***Environmental Protection Act 1986*****Section 43A****NOTICE OF DECISION TO CONSENT TO AMEND A REFERRED PROPOSAL  
DURING ASSESSMENT****PERSON TO WHOM THIS NOTICE IS GIVEN**

Greenbushes Lithium Mine: Waste Rock Landforms, Salt Water Gully Dam and additional clearing for infrastructure  
Assessment No. 2496

Attachment 1 - Amended proposal content document and figure/s showing the new approved proposal

Figure 1-2: Changes between existing DE and Proposed s43A DE

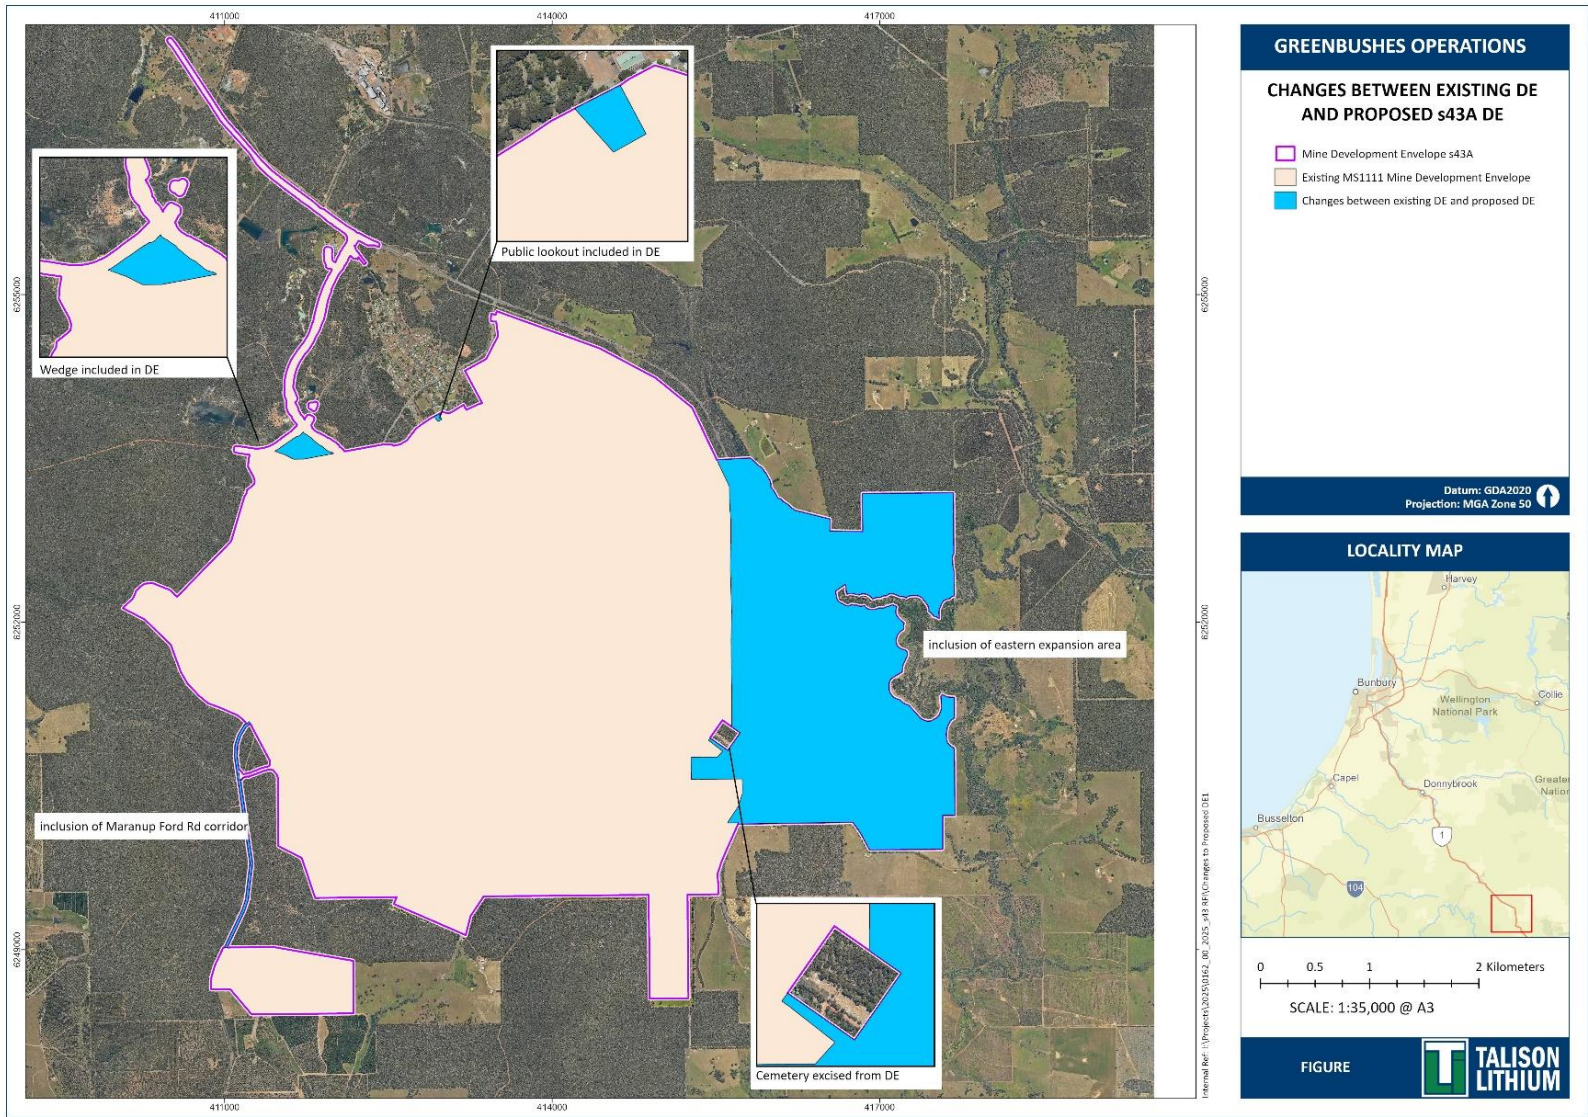
- excise the Greenbushes Pioneer Cemetery from the DE (4 ha reduction)
  - include the Greenbushes Mine Lookout into the DE (0.25 ha increase)
  - include additional previously cleared and rehabilitated areas associated with the Mine Services Area (31 ha)

Proposal element	Location/ description	Existing proposal extent, capacity or range	Referred proposal extent, capacity or range	Proposed amendments	Total proposal extent, capacity or range
Water management infrastructure	Figure 1-4.			No change to footprint.	
Supporting infrastructure corridors	Figure 1-4.			No change to footprint.	
CGP4 Infrastructure	Figure 1-4.			No change to footprint. Reference to workshops and laydown have been removed. The overall disturbance footprint remains unchanged.	
Rehabilitation material stockpile (RMS) area	Figures 1-4 and 1-10.			1 ha increase in the clearing of native vegetation. Note: This figure excludes the clearing of plantation associated with the expansion of the RMS area.	
Mixed use area	N/A			Removal of this proposal element as it will be part of the S2 WRL. No change to clearing disturbance	
Cemetery	Figure 1-2 and 1-3.			4 ha reduction DE to excise the cemetery

Proposal element	Location/ description	Existing proposal extent, capacity or range	Referred proposal extent, capacity or range	Proposed amendments	Total proposal extent, capacity or range
Mine lookout	Figure 1-2 and 1-3.			0.25 ha increase to DE to include lookout, no additional clearing required.	
Hester Brook buffer	Figure 1-3.			17.5 ha reduction in DE to maintain a 50m buffer along the length of Hester Brook registered heritage site	
<b>Operational Elements</b>					
Damming and abstraction of surface water for mine site water supply.	Figures 1-1, 1-2, 1-4 and 1-8.	N/A	Abstraction of up to 1 GL/a from Saltwater Gully Dam.	No change.	Abstraction of up to 1 GL/a from Saltwater Gully Dam.
Waste Rock Landform Construction		Waste Rock Landform height of 330 m AHD and area of 355 ha.	WRL height of 330 m AHD and area of 727 ha (includes existing Floyds WRL, S2 WRL and S8 WRL).	Increase of WRL footprint by 63 ha, including removal of mixed use element and larger S8 footprint	WRL height of 330 m AHD and area of 790 ha (includes existing Floyds WRL, S2 WRL and S8 WRL).

Figure 1-5: Prior disturbance of 31ha of Previous Mine Disturbance and Rehabilitation Areas

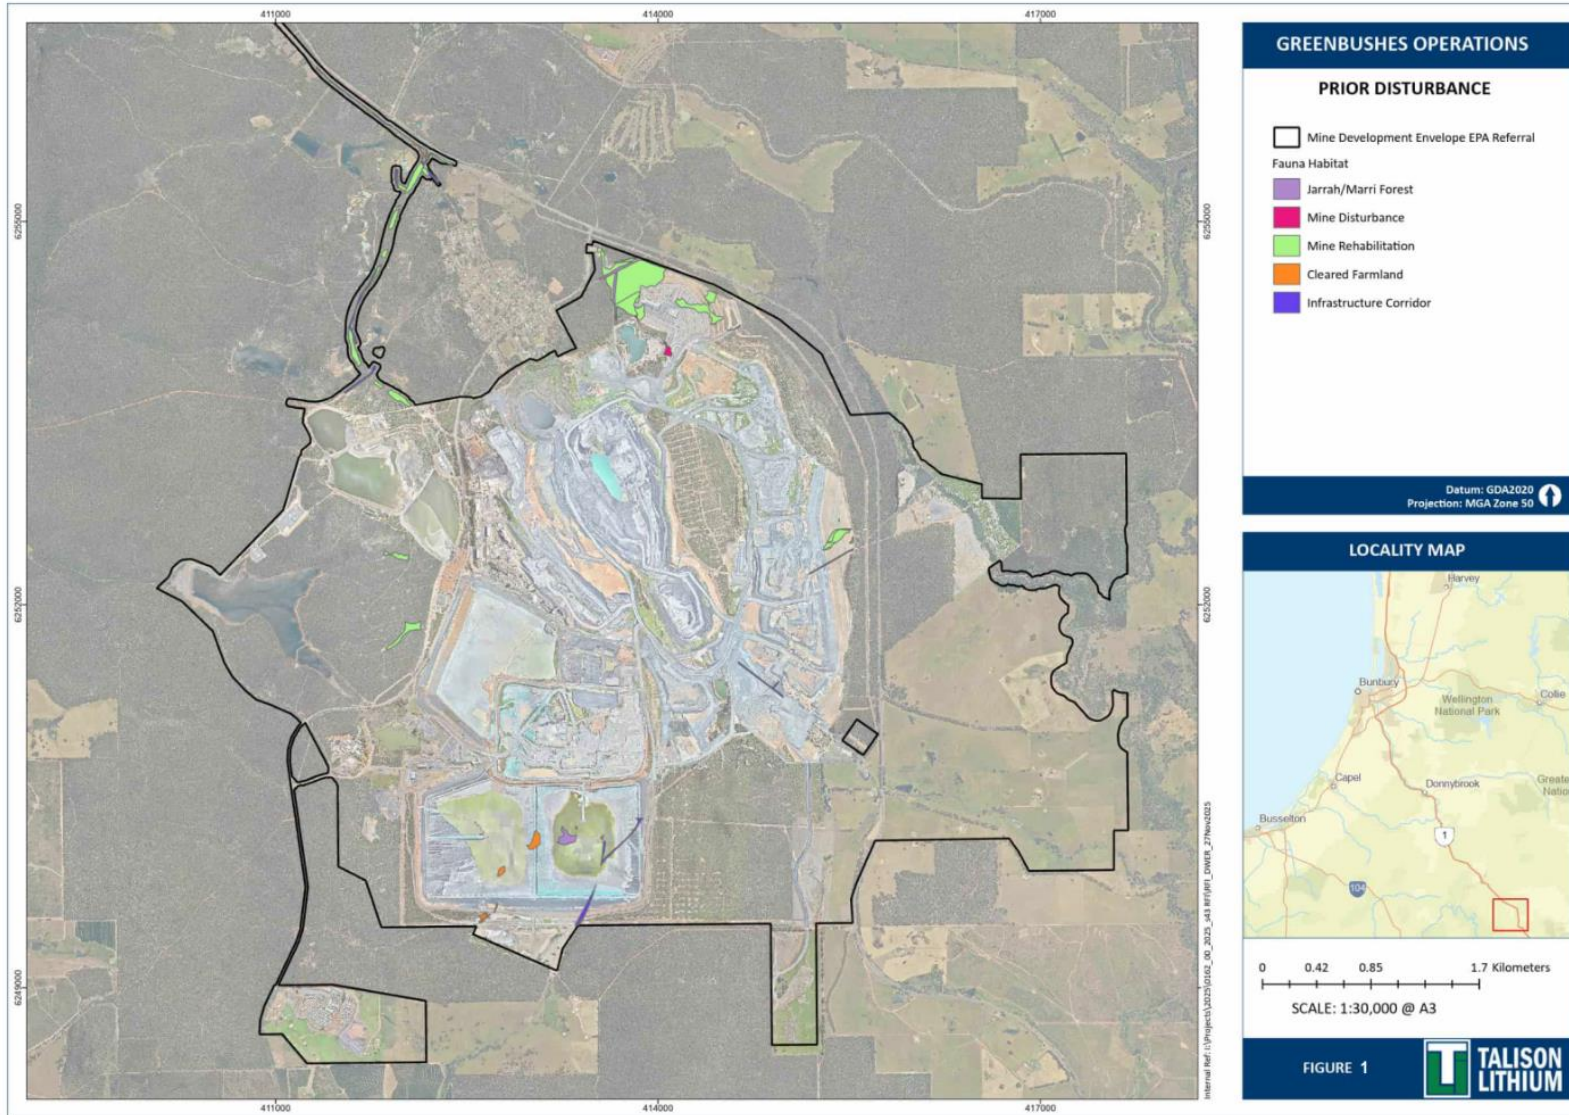
Proposal element	Location/ description	Existing proposal extent, capacity or range	Referred proposal extent, capacity or range	Proposed amendments	Total proposal extent, capacity or range
Mine services area (existing mine infrastructure)	Figure 1-5 and 1-6.			Talison is increasing the clearing of previous mine disturbance and rehabilitation areas that relate to the MSA to ensure that MS1111 accurately captures all land clearing already completed, as well as future clearing required for the proposed expansion. This includes an increase of 31 ha in areas of previously disturbed by mining and rehabilitation activities	
Waste rock landforms (S2 & S8)	Figure1-7.			<p>The reduced size of SWG Dam enables a small increase in the footprint of the S8 WRL. S2 increases due to the removal of the mixed use area element. Changes to footprint include</p> <ul style="list-style-type: none"> <li>• S2 WRL increases by 60.5 ha</li> </ul>

Figure 1-7: Proposed Changes to WRL S2 and S8

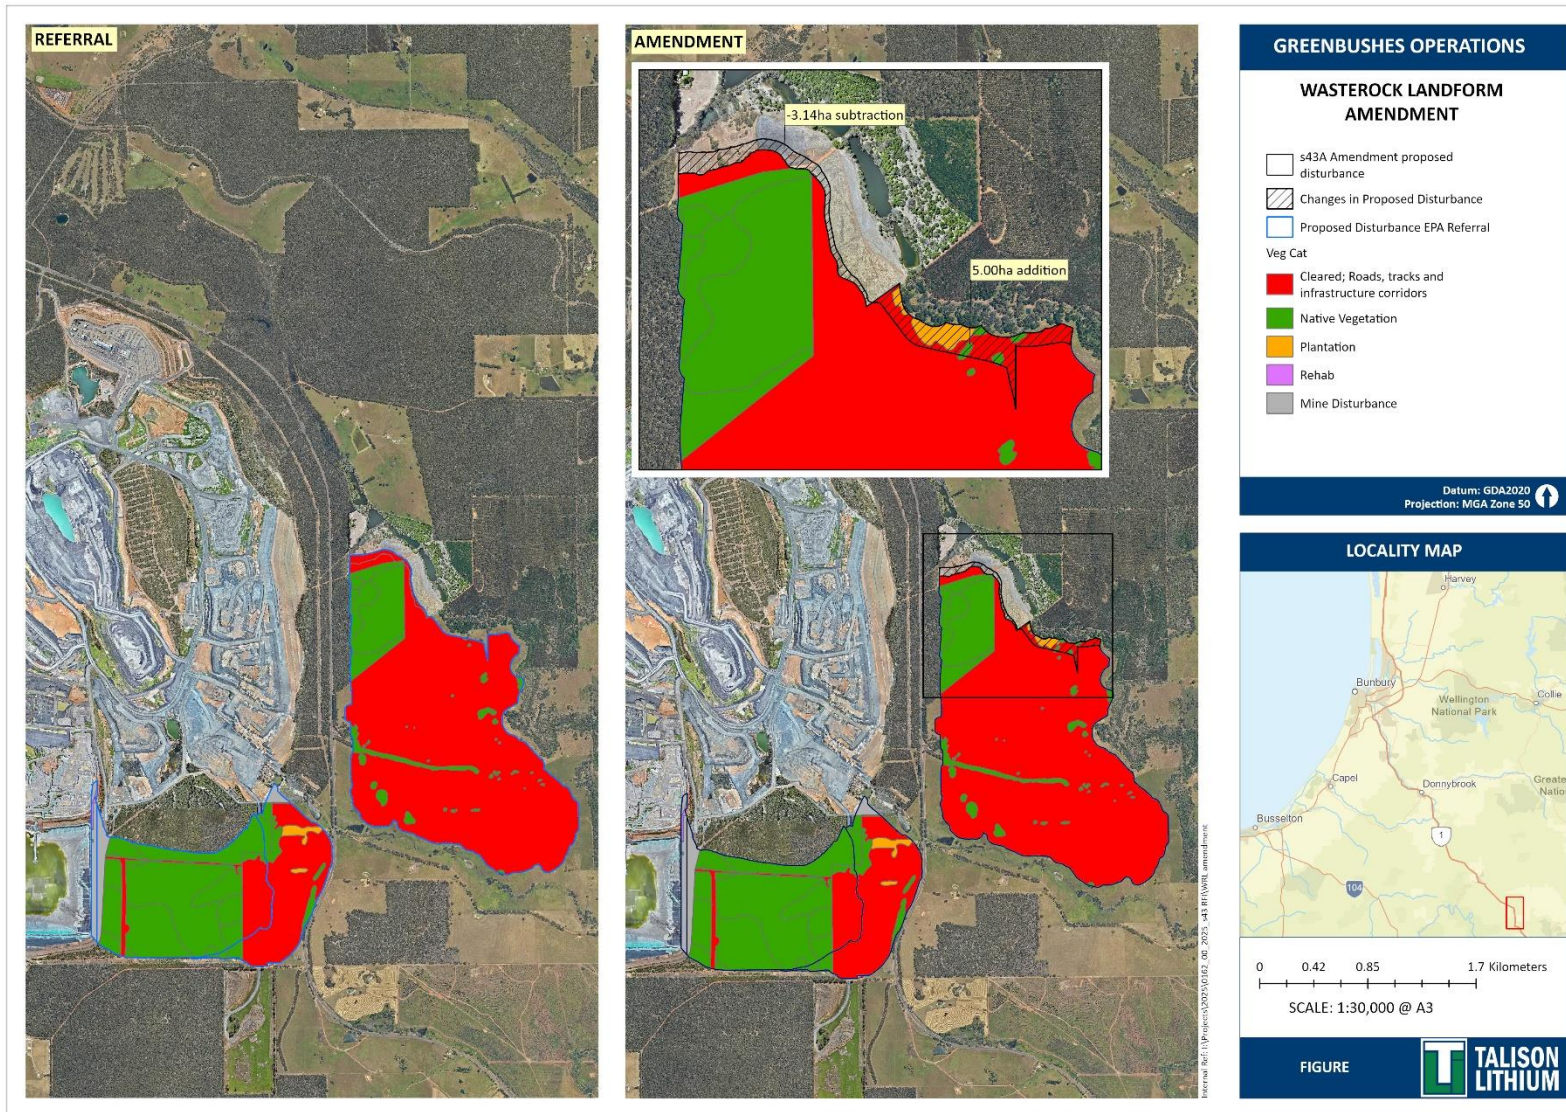
- re-design the rehabilitation material stockpiles (RMS) footprint (2 ha increase)
- re-design the waste rock landforms (WRLs) S2 and S8, including the removal of the proposal element Mixed Use Area to integrate the area into the S2 footprint (no change in overall disturbance)
- remove the referred laydown area east of Salt Water Gully Dam (removed with the heritage buffer)
- increase the total area for operational element WRL Construction by 63 ha (from 727 ha to 790 ha)
- administrative changes to clearly define the proposal elements and correct an error in the proposal content document to align the referred area of the DE with the referred spatial data (2,826 ha corrected to 2,824 ha).

Figure 1-8: Salt Water Gully Dam Changes

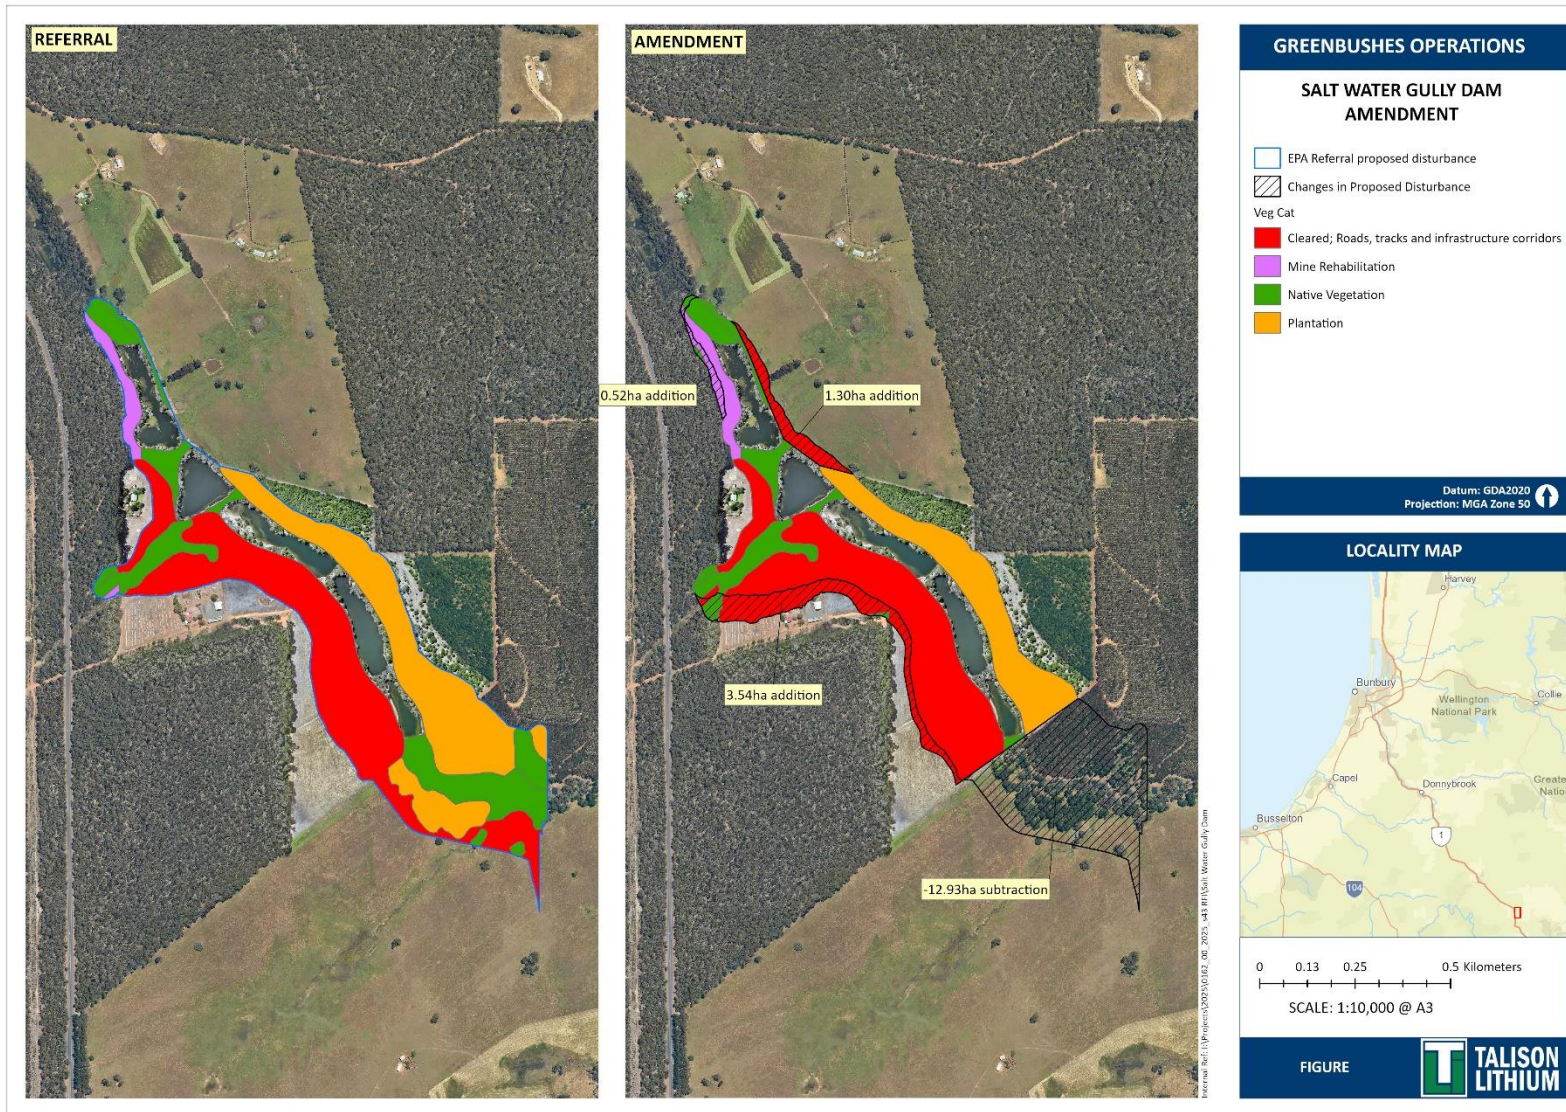
- re-design the Salt Water Gully Dam and reduce the dam expansion footprint (9 ha reduction)
  - excise a buffer to Hestor Brook from the DE to maintain a 50 metre (m) buffer along the length of Hestor Brook (17.5 ha reduction in DE)

- reduced impact to water quality through the re-design of the Salt Water Gully Dam and exclusion from the process water circuit
  - avoidance of potential impact to European Heritage through the removal of the cemetery from the DE

Figure 1-9: Dam Raise Amendment

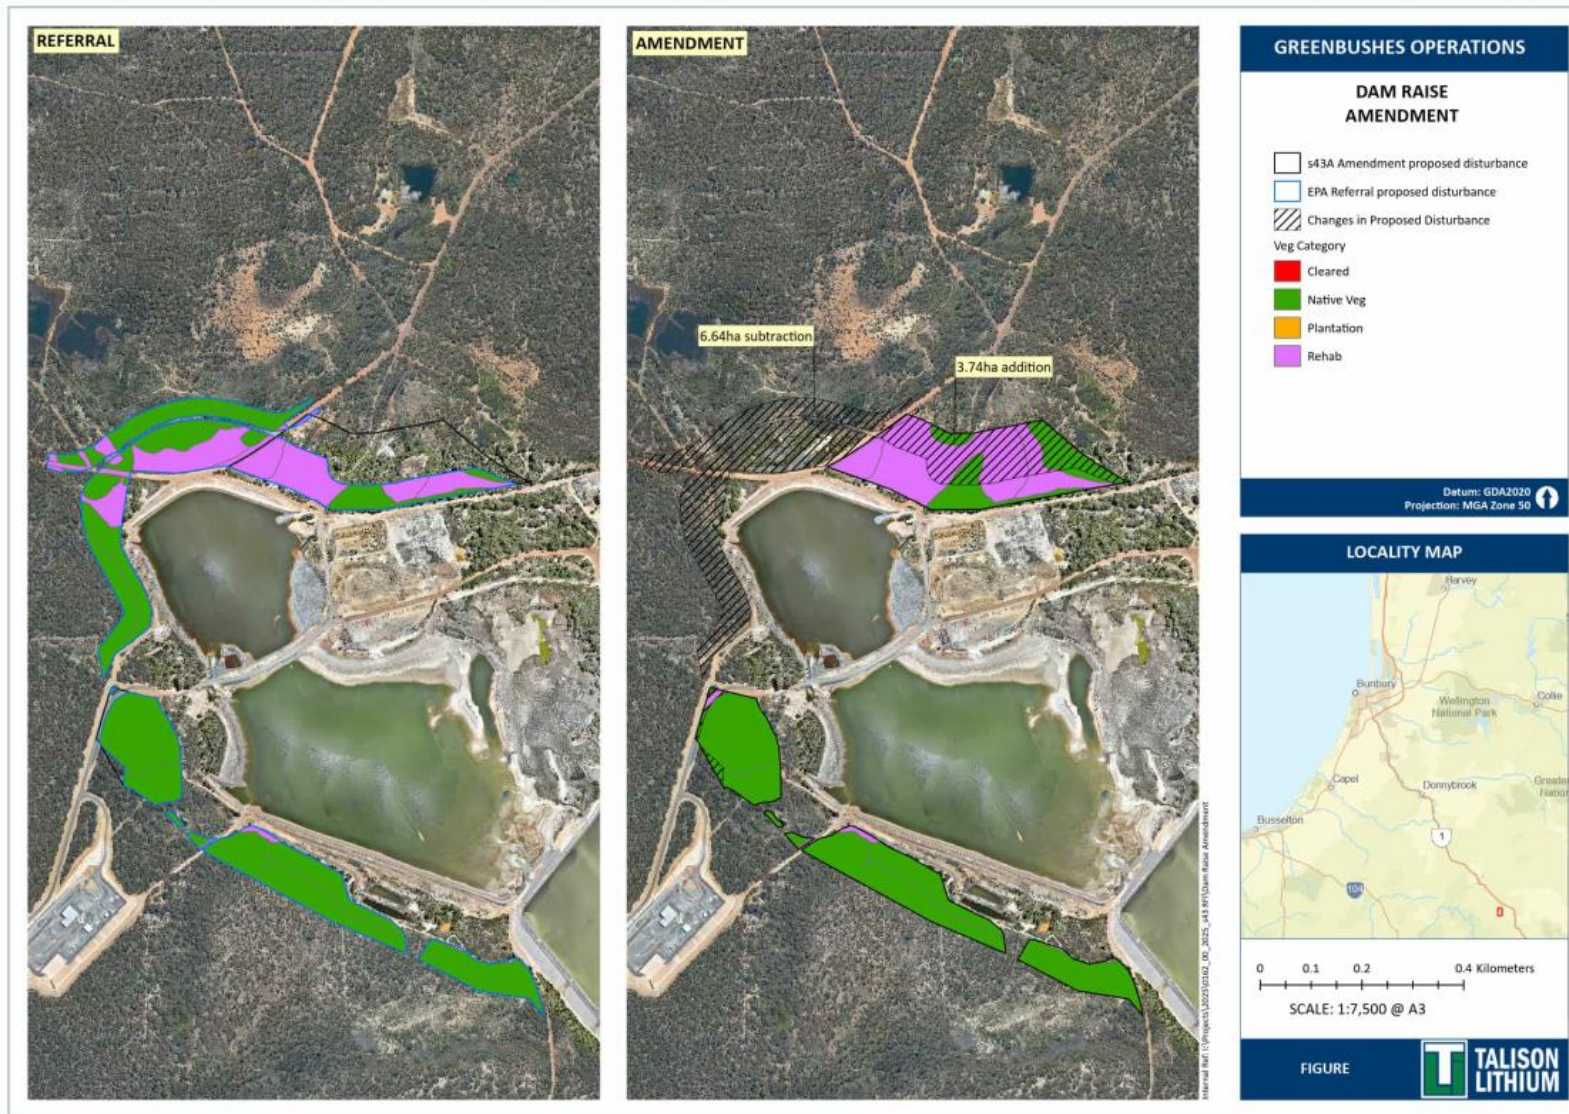
- change in physical elements of the proposal to:
  - modify the Austins and Southampton dams design to implement an upstream dam raise rather than downstream dam raises (11.75 ha reduction in DE and ~3 ha reduction in footprint)

Proposal element	Location/ description	Existing proposal extent, capacity or range	Referred proposal extent, capacity or range	Proposed amendments	Total proposal extent, capacity or range
				<ul style="list-style-type: none"> <li>S8 WRL increases by 2 ha</li> <li>No change to overall disturbance footprint for this element</li> </ul>	
Saltwater gully dam	Figure 1-8.			Reduction of dam area to avoid heritage identified by Wagyl Kaip survey in November 2025. Reduction of 3 ha of native vegetation clearing and reduction 4 ha of previous mine disturbance and rehabilitation areas	
Southampton and Austins dams	Figures 1-3 and 1-9.			<p>2 ha reduction in clearing of native vegetation and 1 ha reduction in clearing of previously rehabilitated areas.</p> <p>Dam raise clearing reduces by 3 ha in total.</p> <p>11.75 ha reduction to the DE.</p>
